Nuclear Reactor Facility
1870 Miner Circle
Rolla, MO 65409-0630
Phone: 573.341.4236
Fax: 573.341.4237
reactor@umr.edu

Subject: Proposed Technical Specification Amendment for Level 1 position for the University of Missouri – Rolla Reactor Facility, LicenseR-79, Docket 50-123.

Figure 6-1 Organizational structure of the University of Missouri related to the UMR Nuclear Reactor Facility

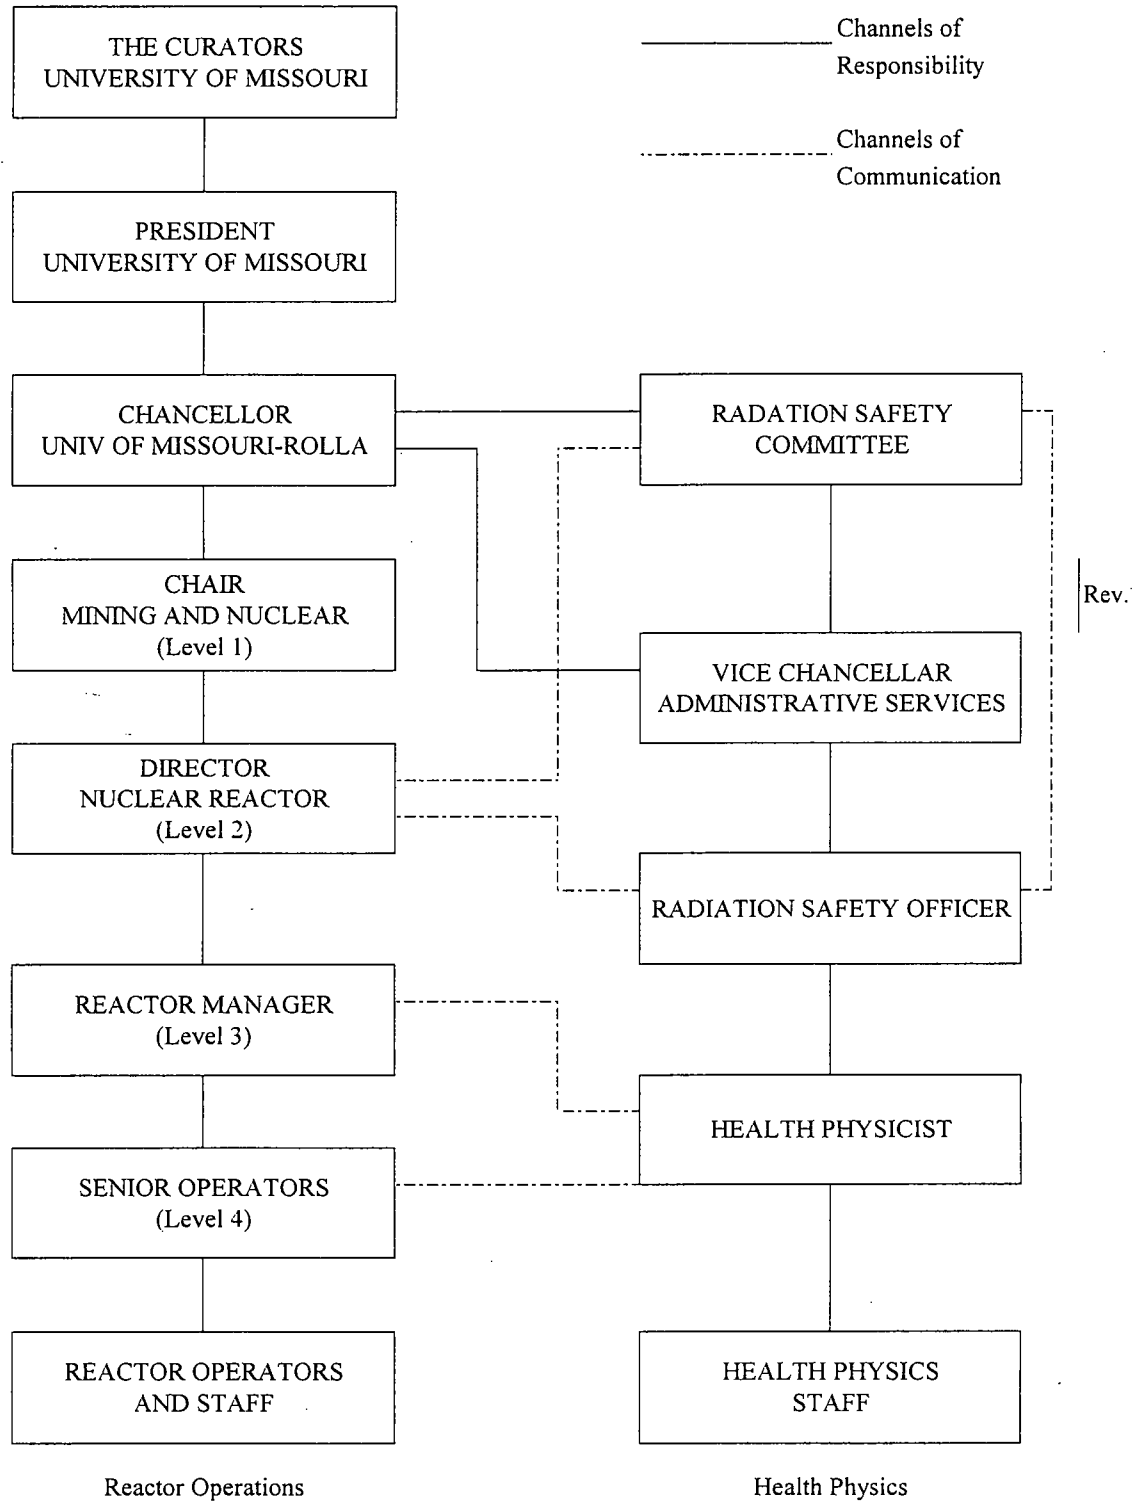
Figure 6-1 lists the Dean of School of Mines (Level 1) in the channels of responsibility.

Figure 6-1 will list "Chair Mining and Nuclear (Level 1)" in place of "Dean School of Mines (Level 1)". Figure 6-1 with this modification is enclosed at the end of this letter. | Rev.
